EVERWIN DESIGN IMPROVEMENT ANNOUNCEMENT

OLD PN100 VS. NEW PN100B

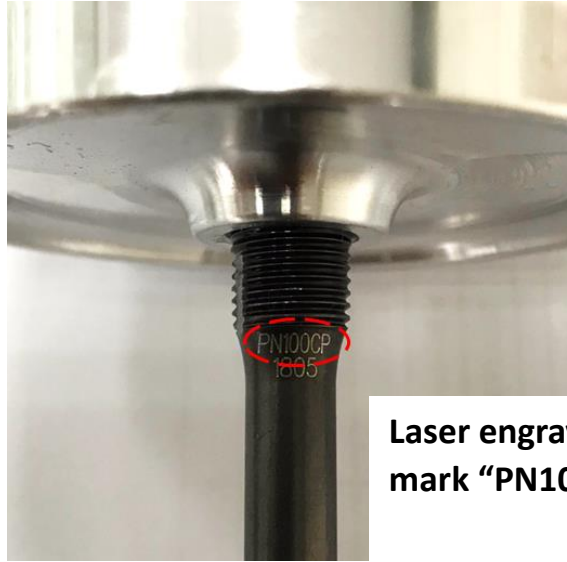
Old PN100	New PN100B
<p data-bbox="92 367 480 398">Old Main Piston Unit 103068</p>  <p data-bbox="464 835 756 965">No laser engraving besides production month</p>	<p data-bbox="805 367 1209 398">New Main Piston Unit 109011</p>  <p data-bbox="1193 831 1458 909">Laser engraved mark "PN100CP"</p>
<p data-bbox="92 1014 323 1046">Old Nose 100334</p>  <p data-bbox="587 1312 743 1391">No laser engraving</p>	<p data-bbox="805 1014 1051 1046">New Nose 109009</p>  <p data-bbox="1294 1285 1458 1408">Laser engraved mark "CP"</p>

1. To upgrade existing **PN100 to PN100B**, follow instructions hereunder
 - A. To upgrade - Replace Nose, **109009** and Main Piston assembly, **109011**
 - B. **103416** - For complete nose and driver assemblies with door assembly.
 - C. **100317** - For complete nose and driver assemblies without door
 - D. If you need just a nose, order new nose, 109009 plus the new main piston assembly, 109011
2. PN100 nose, **100334** will be discontinued October, 2018
3. PN100 main piston unit, **103068** – will support existing PN100 for 2 years.
4. New main piston unit, **109011** might fit older noses due to worn out driver guide area.
